Redevelopment of the Sydney Football Stadium Stage 2 Modification 3

State Significant Development Modification Assessment
(SSD-9835-Mod-3)

Subtitle: Modification to mezzanine level and signage

Figure 3 | Mezzanine level as approved (left) and proposed (right) (Source: Approved Plans (2019) and Applicant's Modification Application, 2020)

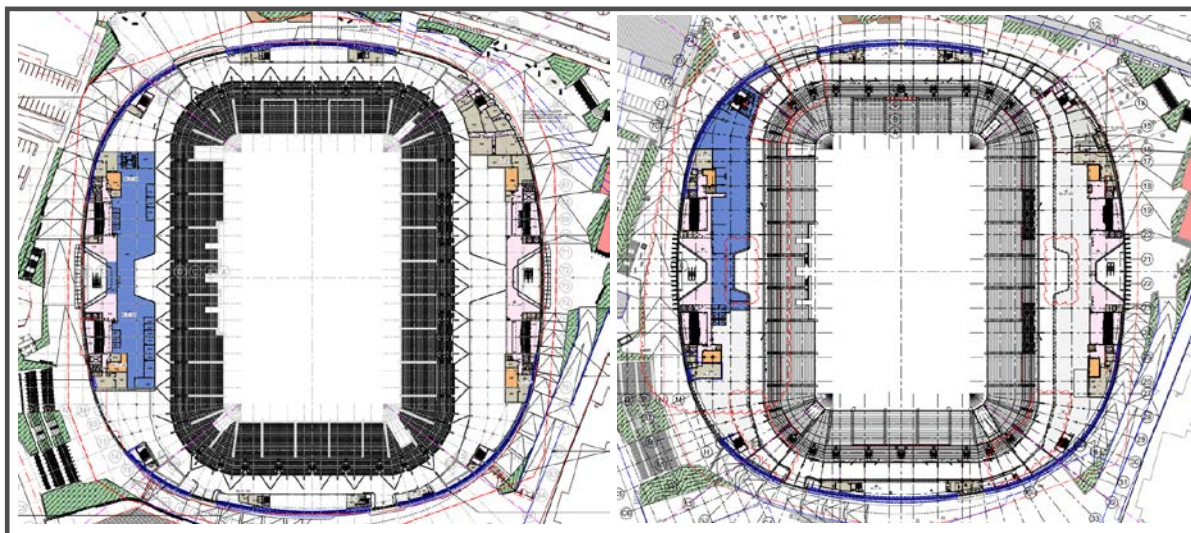
Blue shaded areas in **Figure 3** show the relocated administration area, including fit out, to the north of the western mezzanine level.

Based on refinements and an increased understanding of operational requirements, the Applicant is seeking to relocate the approved administration facilities of the SCSGT, located at the mezzanine level of the stadium. The facilities are proposed to move to the north-western corner of the stadium and would remain on the mezzanine level. The location of the administration facilities as currently approved, would remain vacant with no fit-out.

The Department has considered the proposed amendments to the mezzanine level, including the relocation of the administration facilities and the increase in mezzanine slab. The Department considers that the relocation of the administration facilities would result in negligible change to environmental impacts as these works were considered as part of the original application, albeit at an altered location. Additionally, the increase to the mezzanine level is considered to be of minor environmental impact during construction as the works are a minor extension to works already approved. The construction requirements of the stadium as approved, including works at the mezzanine level, would continue to apply to the works associated with the mezzanine extension and it is considered that existing conditions of consent would enable the modifications to the mezzanine level to be undertaken with negligible environmental impacts.

The Department is satisfied that the modifications at the mezzanine level can be undertaken with negligible environmental impacts in accordance with revised plans and the existing conditions of consent.

Figure 4 | Areas of additional mezzanine (shown in red bubbles) (Source: Applicant's Modification Report, 2020)

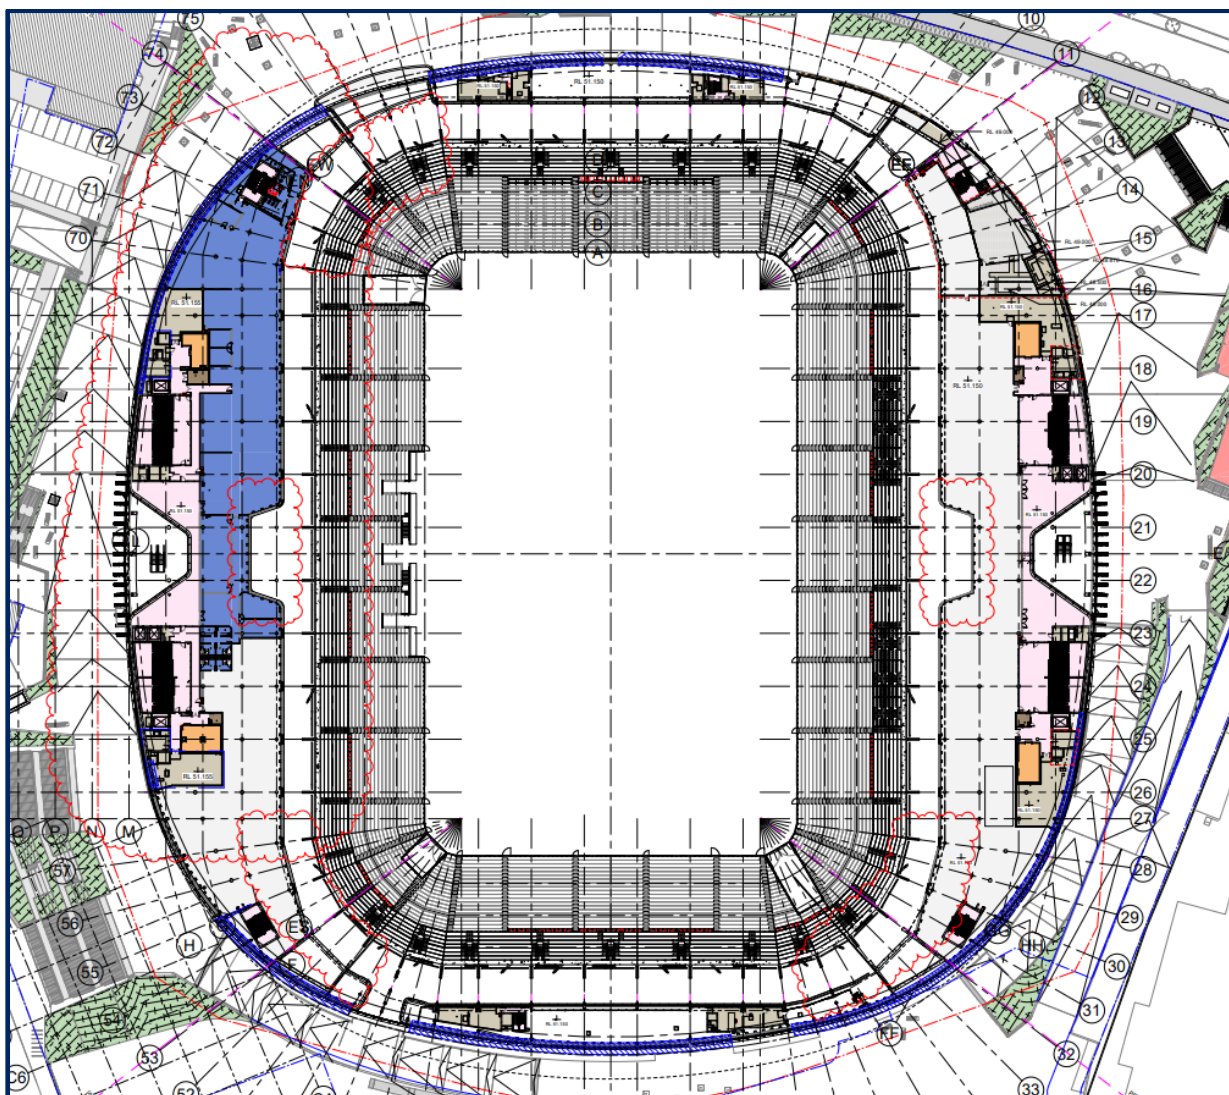
Furthermore, additional detailed design of the stadium has indicated that there are additional areas that could be utilised at the mezzanine level by extending the approved slab. The use of these areas is yet to be confirmed and no fit-out or use is proposed as part of this modification with the areas to remain vacant.
